GARAGE ADDITION & CARPORT ENCLOSURE

10080 MAPLEWOOD DRIVE - T.B. COUGHLIN

SITE INSPECTION SHEET

LOCATION DIAGRAM

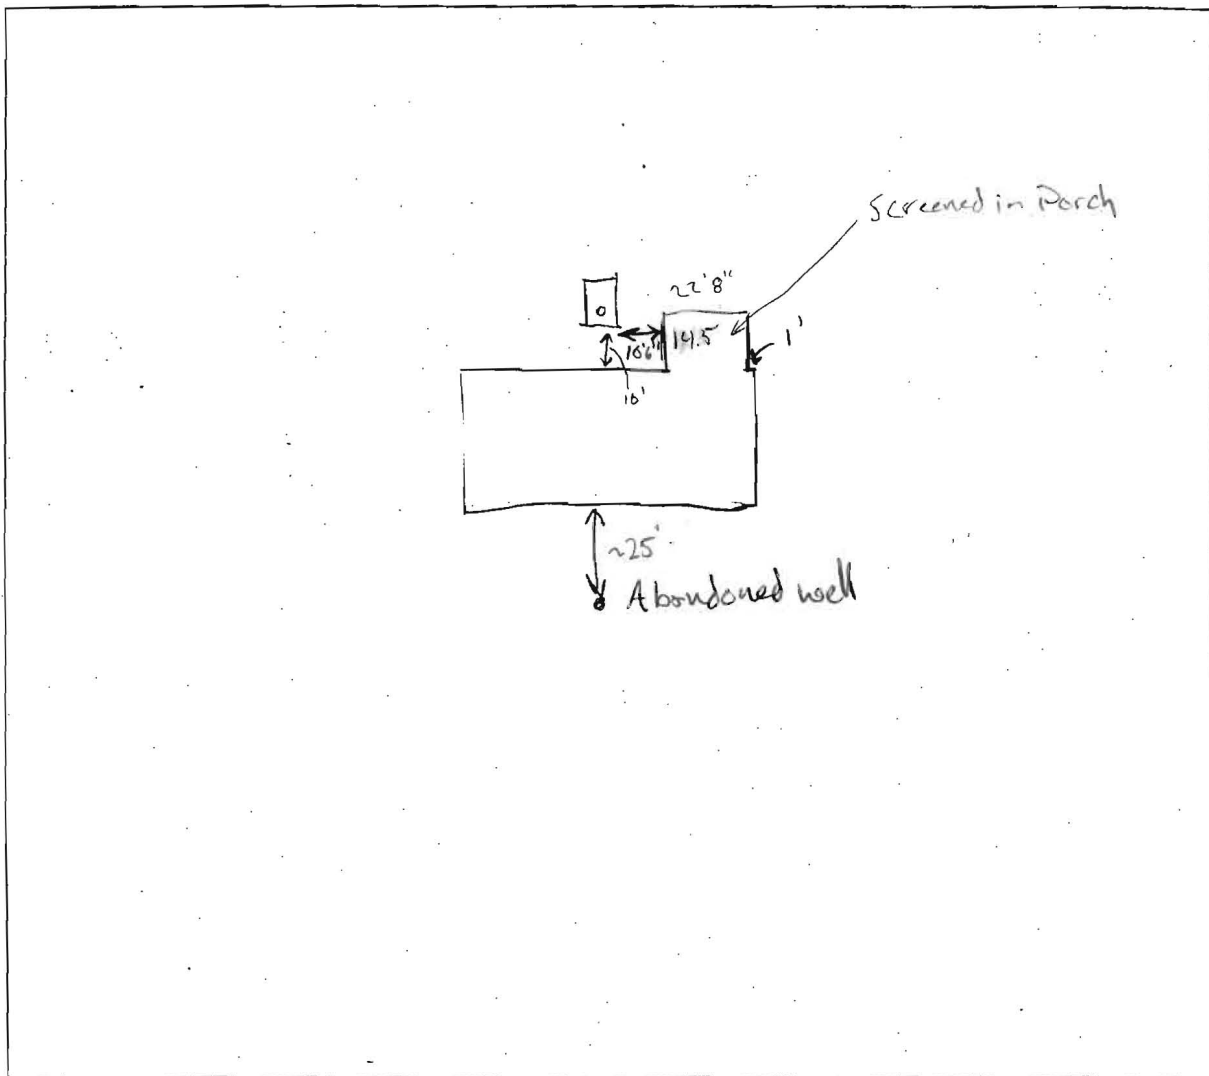
COMMENTS: Tank appears to be working good.
Contractor dug down and exposed corner of septic tank closest to screened porch and measured 10.5' to tank corner. Tank is exactly 10' off house. Told contractor to bring scale drawing of addition. Addition will occupy exact space of screened in porch shown on
DATE: 6/6/05 INSPECTOR: GAC
